Colorado Springs, CO
Planning and Development

Final Report - Corrections Required
Application No. DEPN-22-0222

Description : A new 53 unit apartment complex
Address : 0 8th ST Colorado Springs CO 80905
Record Type : Development Plans
Document Filename : Development Plan Set

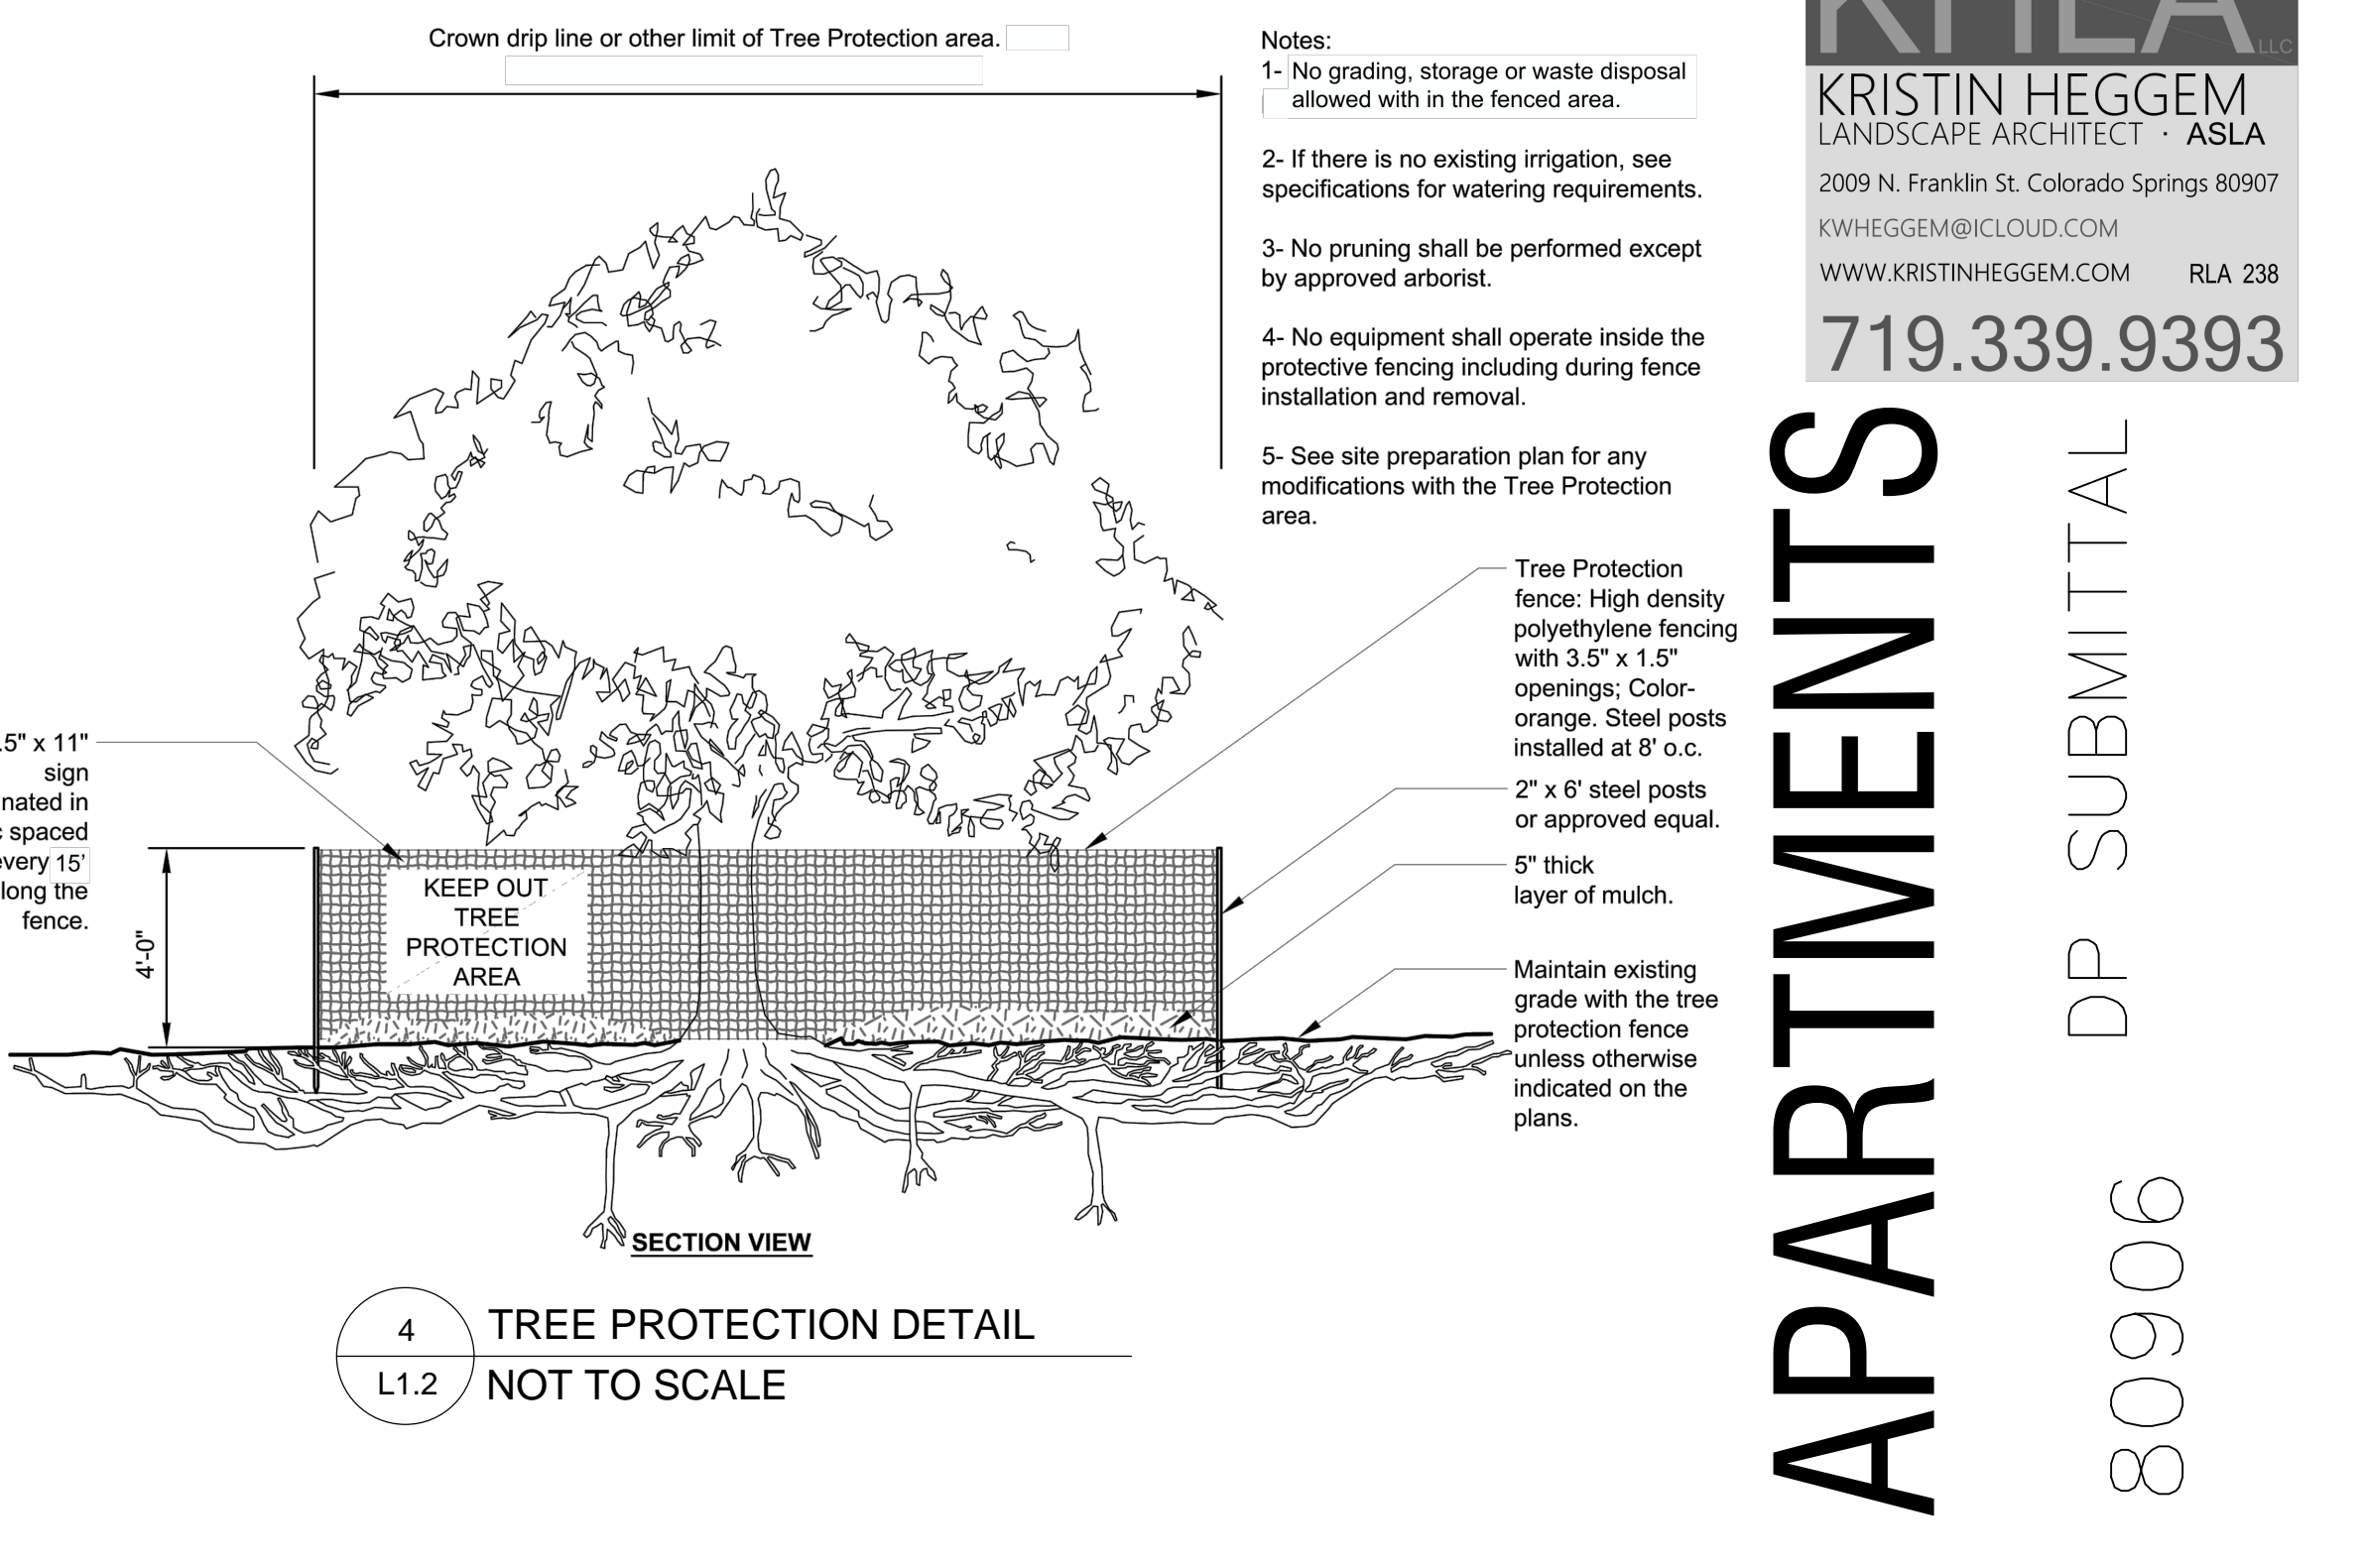
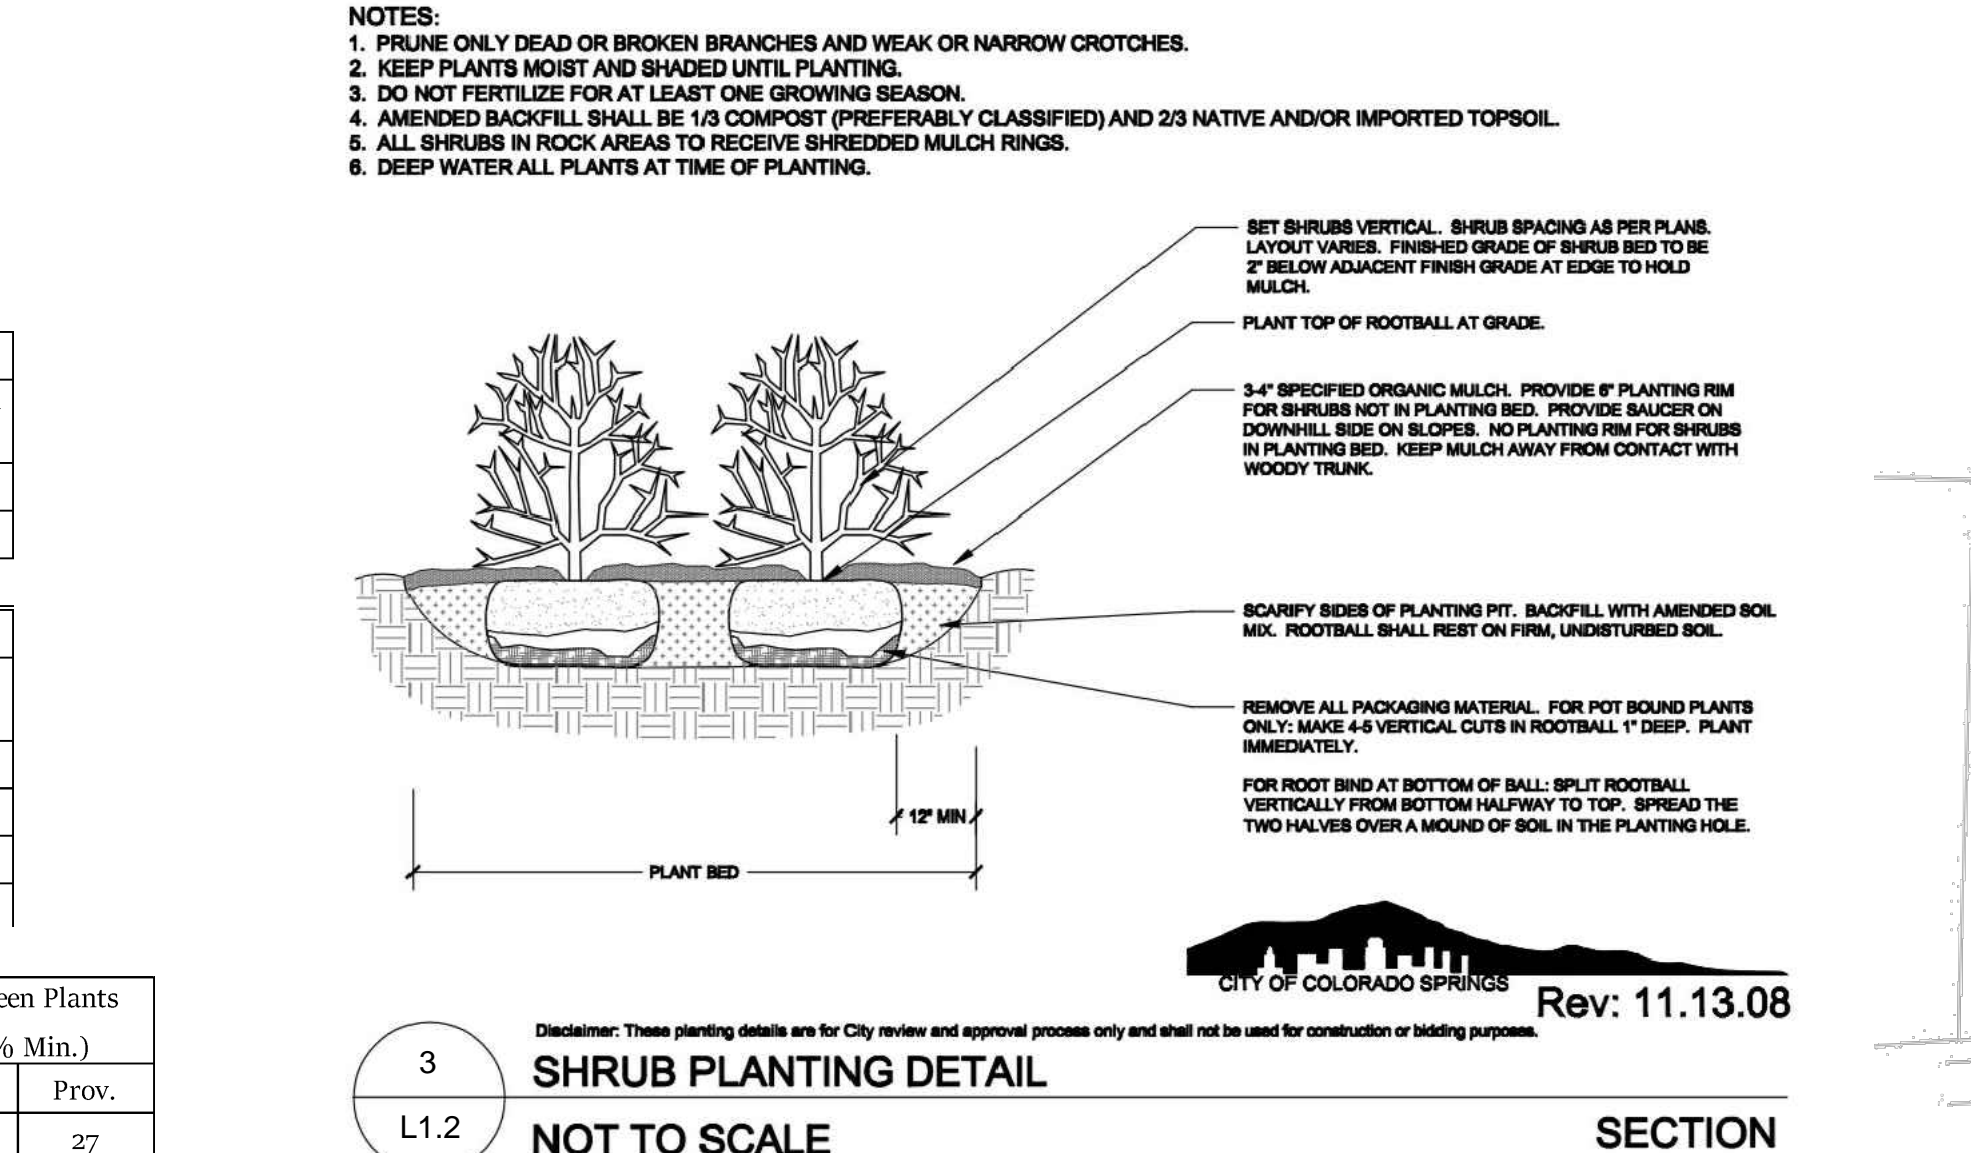
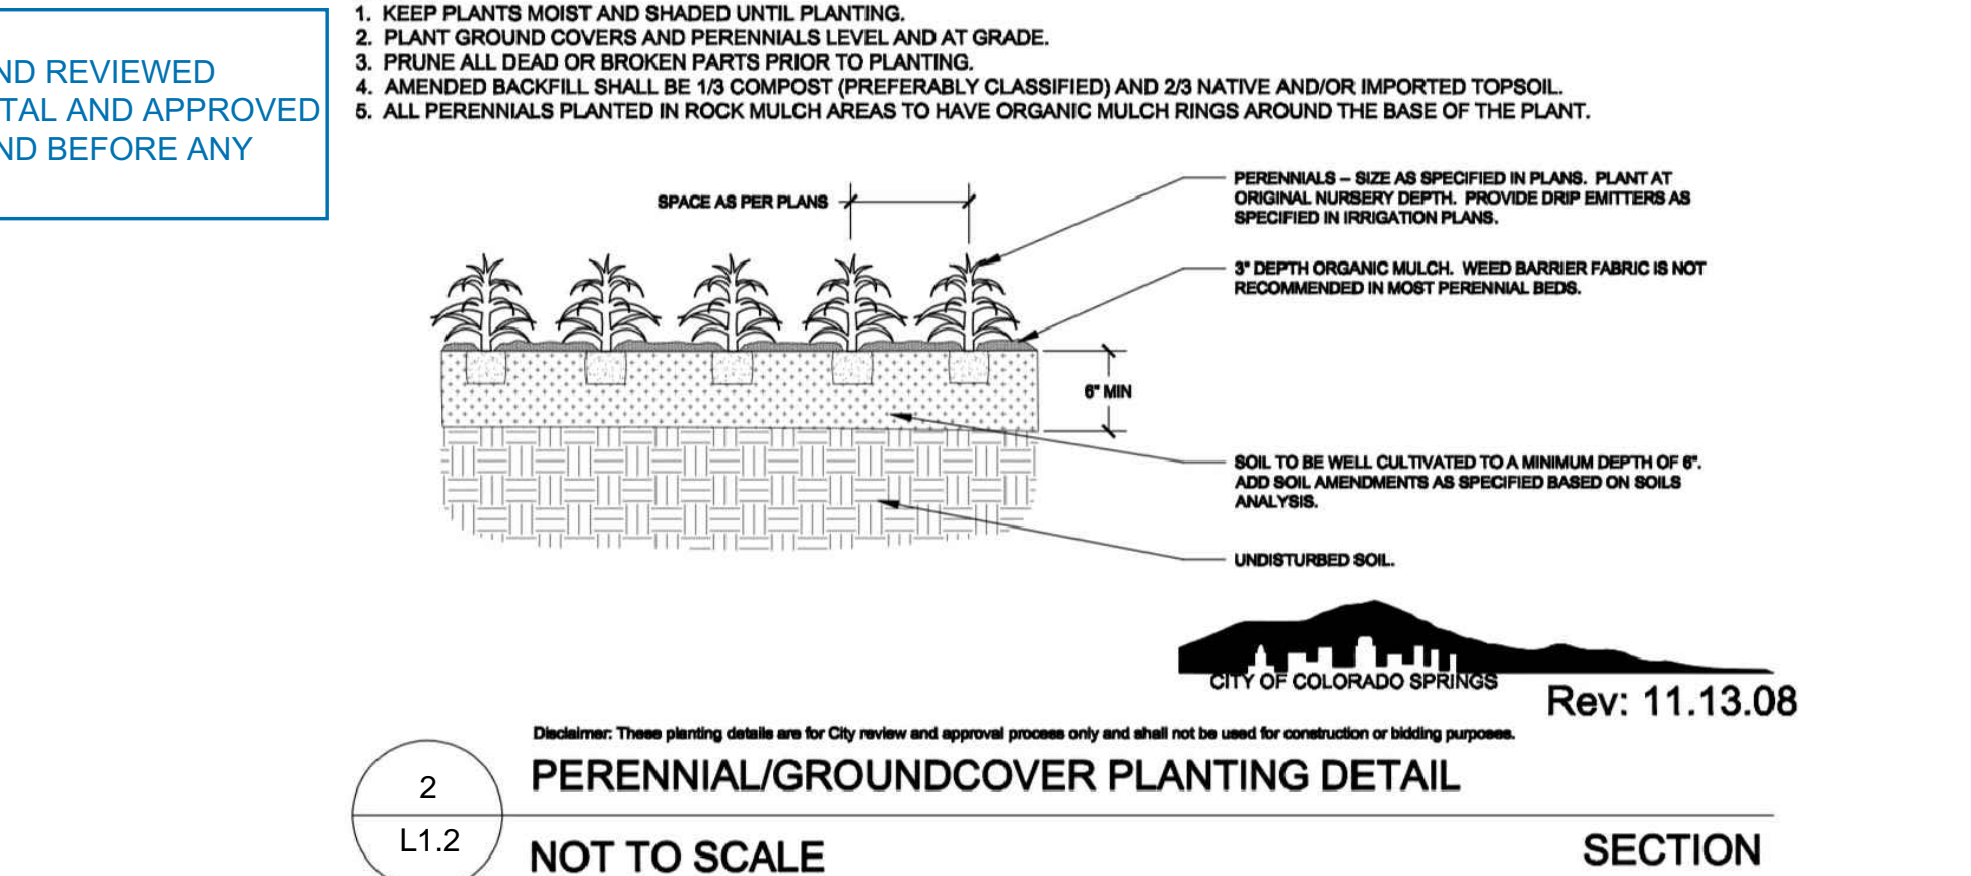
With the overall size of the project, the required existing soils analysis report will be submitted with the Final Landscape Plan or at the latest with the irrigation plan. If the soils report will be submitted with the irrigation plan, update note 3 to read "The required Soil Analysis Report is required to be submitted and approved with the Irrigation Plan submittal and before any landscape construction. This would include completing the soil sampling and submitting the samples to a soils lab for testing. A separate lab test report and soil preparation recommendations (amendment/fertilizer amounts and application rates) for each type of proposed landscaping (Shrub beds/Sod/Native Seed) will need to be provided to City Staff for review and approval."

Add the following notes to this section:
AN IRRIGATION PLAN SHALL BE SUBMITTED AND REVIEWED CONCURRENT WITH BUILDING PERMIT SUBMITTAL AND APPROVED PRIOR TO ISSUANCE OF A BUILDING PERMIT AND BEFORE ANY IRRIGATION CONSTRUCTION.

Update note 16 to include minimum amount of soil amendments for the native seed areas (2 CU per 1000 SF) This can be revised based on pending soils report.

Appendix E: Schematic Landscape Diagram

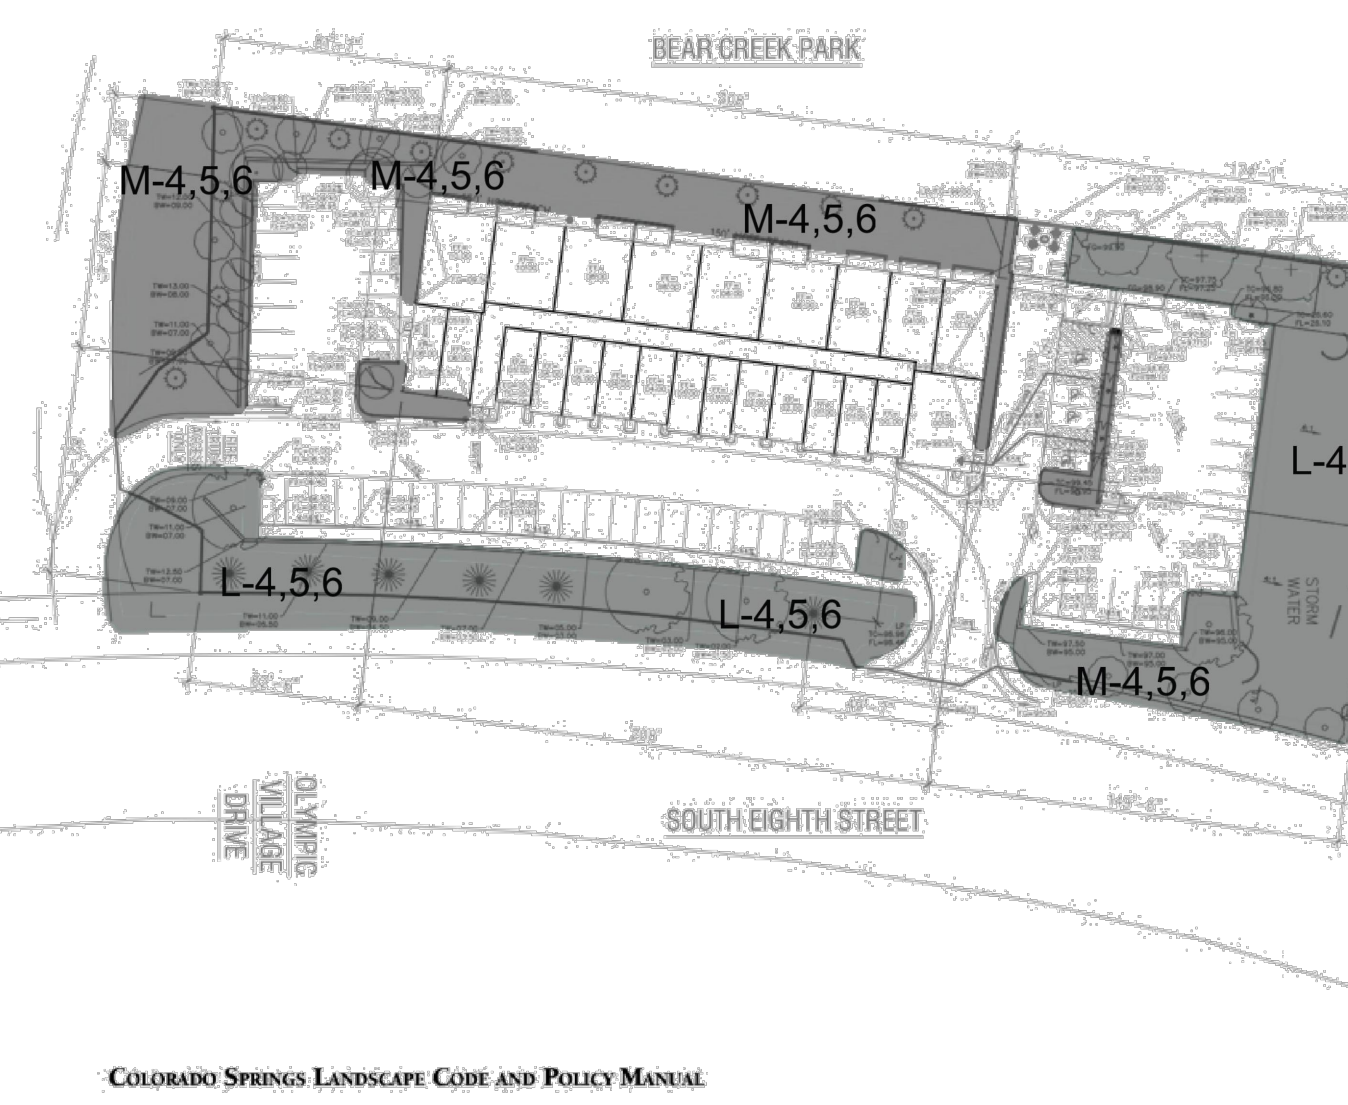
Update this to read "25'", you are meeting the required setback for 8th street. See sheet 6.

Add the following note below the charts "All existing trees being used to meet site landscape requirements shall be replaced if not in a healthy condition"

Update this to read "*** Alternative Compliance requested due to site constraints"

Include the number of existing trees being used to meet this requirement, example "16/13 (6 existing)"
